CHANGES FROM BASE PRODUCT UDS-4.5SC (3720) TO UDS-4.5SC(COG) (6536):

UDS-4.5SC(COG)

Part No  
6536

BE-004550-00-21

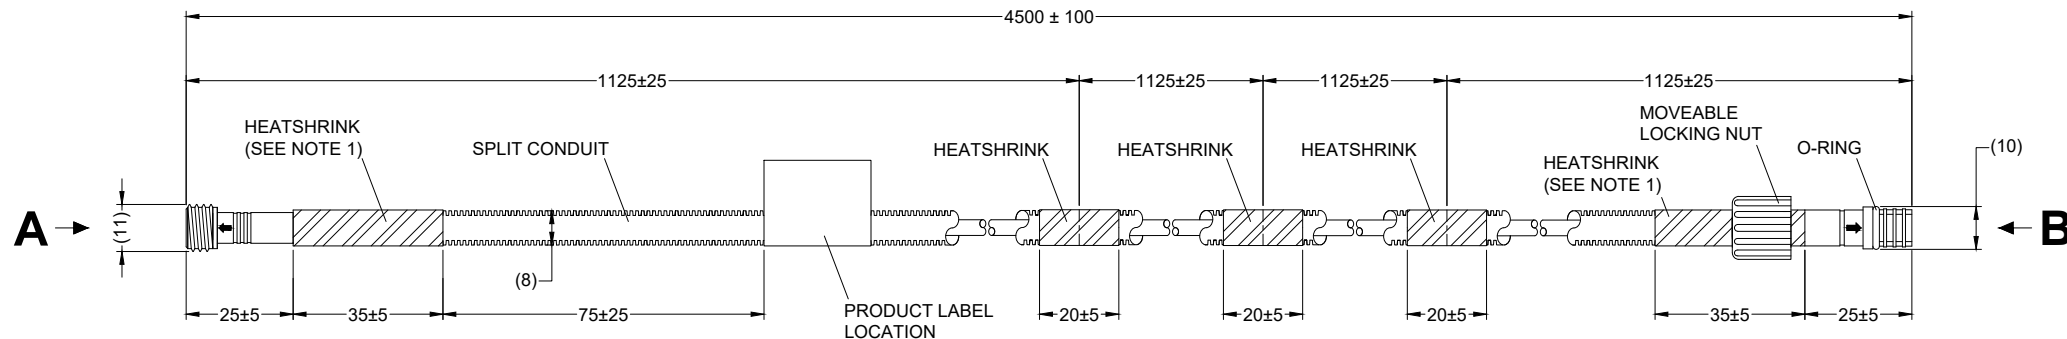
1. SPLIT CONDUIT ADDED TO LENGTH OF CABLE.
2. HEATSHRINK ADDED AT EACH END TO SECURE CONDUIT TO CONNECTOR.
3. HEATSHRINK ADDED AT INTERVALS ALONG LENGTH OF CONDUIT.
4. CABLE LABEL CHANGED FROM UDS-4.5SC (3720) TO UDS-4.5SC(COG) (6536).
